Cobra 67LTD Technical Bulletin 1284

Cobra Communications

TECHNICAL BULLETIN

MODELS AFFECTED: 67LTD

67 LTD
 BASE PCB 401055-B
 PARTS LAYOUT

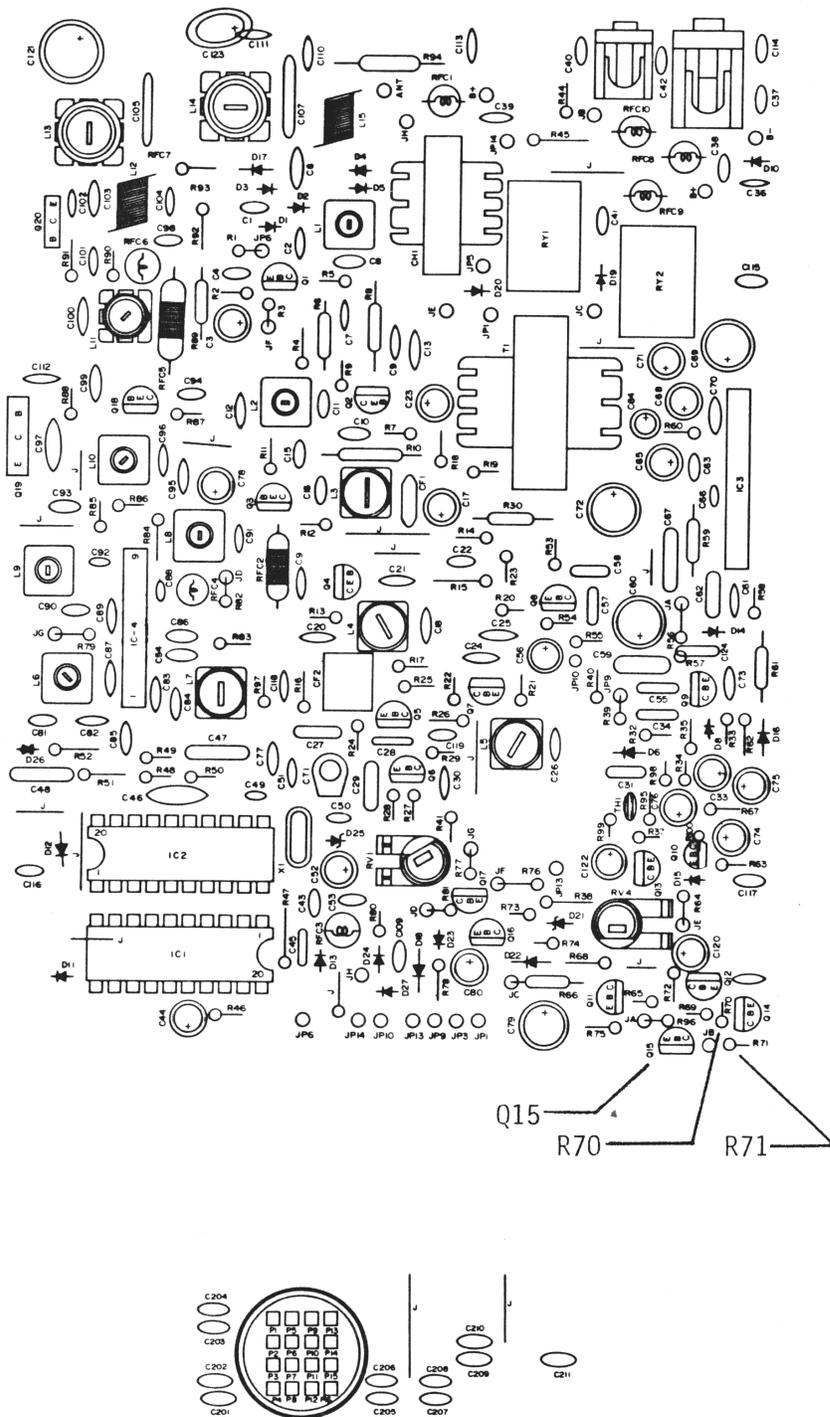
CAUSE: The relay control circuit in the 67LTD causes the CA-63 relay to be de-energized when it should be energized. This condition causes the car radio Audio to be connected to the car speakers instead of the Audio from the 67LTD.

ACTION: Reverse the switching logic of the 67LTD relay control circuit by replacing the PNP device at Q15 with an NPN device. Increase the resistance at R70 and remove the resistor at R71 to improve low temperature operation.

1. Remove both covers of the base unit by removing 8 screws.
2. Unsolder, remove and discard 4.7k ohm resistor at R71. (See attached diagram.)
3. Install and solder a short jumper wire at R71.
4. Unsolder, remove and discard 10k ohm resistor at R70. (See attached diagram.)
5. Install and solder a 20K ohm 1/4 watt resistor (Dynascan P/N 002-104-5-203) at R70.

6. Unsolder, remove and discard MPS9681 at Q-15 (see attached diagram).
7. Install and solder an MPS9418T transistor (Dynascan P/N 176-115-9-004) at Q-15, observing REVERSE POLARITY (ie, E of new transistor in hole marked C, and C of new transistor in hole marked E. The B lead of the new transistor will still be in the hole marked B).
8. Replace both covers with 8 screws.
9. Check for proper CA-63 operation.
